T10/00-297r0

Suggested Changes to Draft Annex D, FCP-2 revision 5 , T10/00-266r0

The changes below are suggested changes to the Draft Annex D, FCP-2 revision 5 (T10/00-266r0). Ladder Diagrams D.5 and D.8 are in partial response to Action item #3 listed in the Joint T10-T11.3 Working Group Ad Hoc meeting minutes (T10/00-433r0). I believe Diagram D.10, the 3rd part of the action item, is correct and needs no change.

Figure D.5 - FCP_XFER_RDY Lost, Unacknowledged Classes

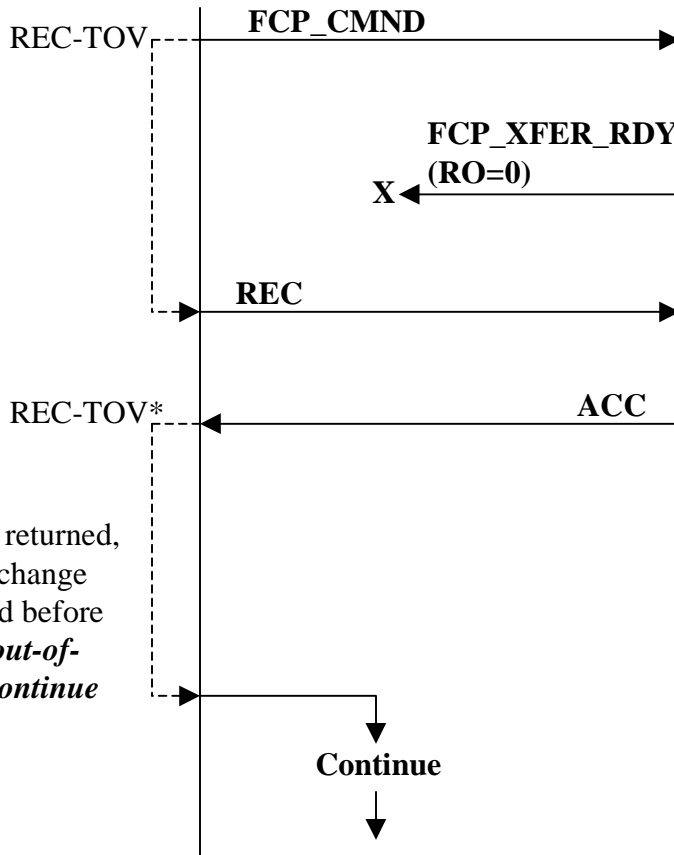
Wait REC_TOV. If FCP_XFER_RDY is returned, continue with the Exchange (ACC to REC arrived before FCP_XFER_RDY, *out-of-order*). Otherwise continue /recovery.

Figure D.8 - FCP_RSP Lost, FCP_CONF not requested, Unacknowledged Classes

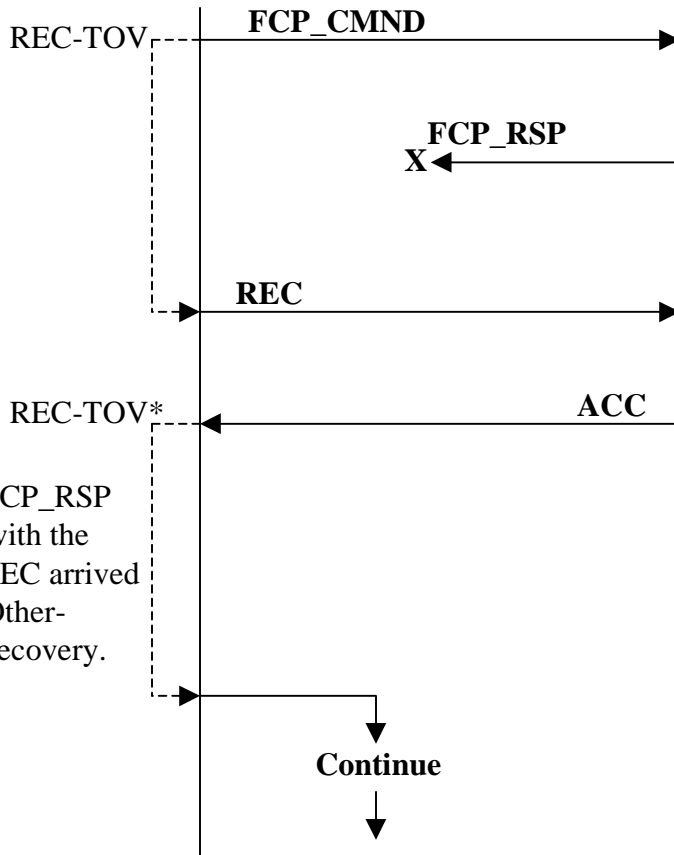
Wait REC_TOV. If FCP_RSP is returned, continue with the Exchange (ACC to REC arrived before FCP_RSP). Otherwise, perform Error Recovery.

Figure D.30 - SRR Lost, Unacknowledged Classes, Abort original Exchange

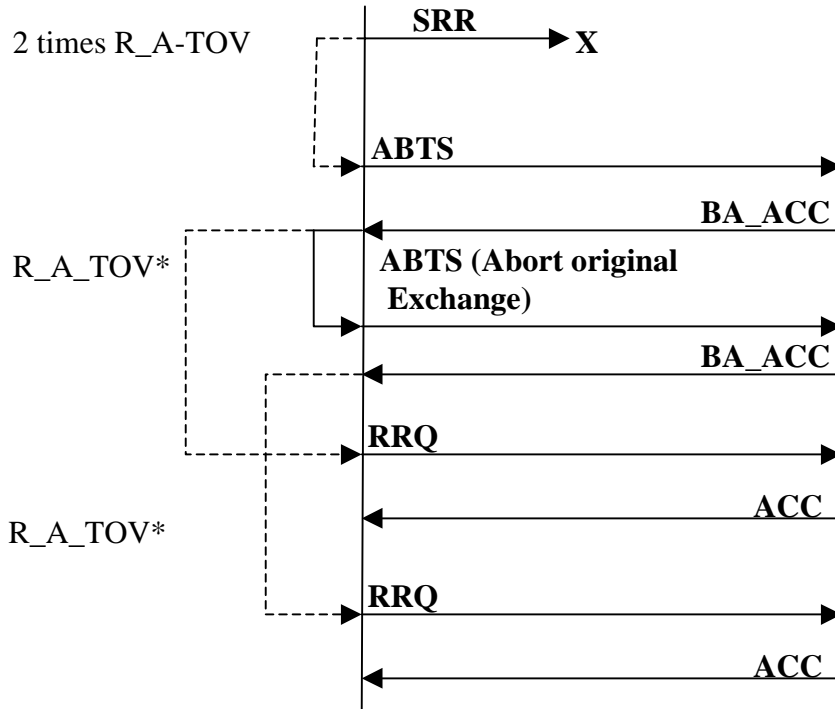
[The payload for the BA_ACC associated with the ABTS of the SRR is SEQ_ID *invalid*, low SEQ_CNT = 0, high SEQ_CNT SEQ_CNT of the ABTS frame.

Rest of text is OK

Figure D.31 - SRR Response Lost, Unacknowledged Classes

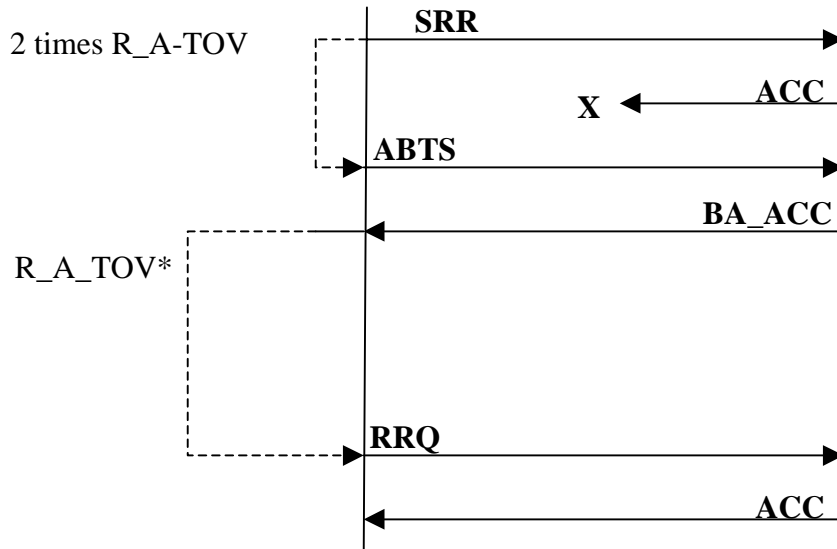
Delete following paragraph

If the SRR Exchange is unknown to the Recipient, the Exchange was completed and the context purged. The payload for the BA_ACC is SEQ_ID invalid, low SEQ_CNT=0, high SEQ_CNT=FFFFh. Recovery Qualifiers are established on both sides.

Following sentence changed and moved above.

In either case, the original Exchange need not be aborted.

*[The SRR Exchange is ...unknown to the Recipient, the payload for the BA_ACC is SEQ_ID valid, SEQ_ID=SEQ_ID of the SRR, low SEQ_CNT=high SEQ_CNT = SEQ_CNT of the ABTS frame. Since no Recovery Qualifier is established, RRQ need not be issued. The Recovery Qualifier is established on the initiator side and must be timed out for R_A TOV. **The original Exchange need not be aborted.***

The context of the SRR Exchange must be preserved for 2 times R_A_TOV, or its OX_ID is reused by the initiator to the same target or the original Exchange is purged.

For in-order delivery, the value of R_A_TOV* is 0.
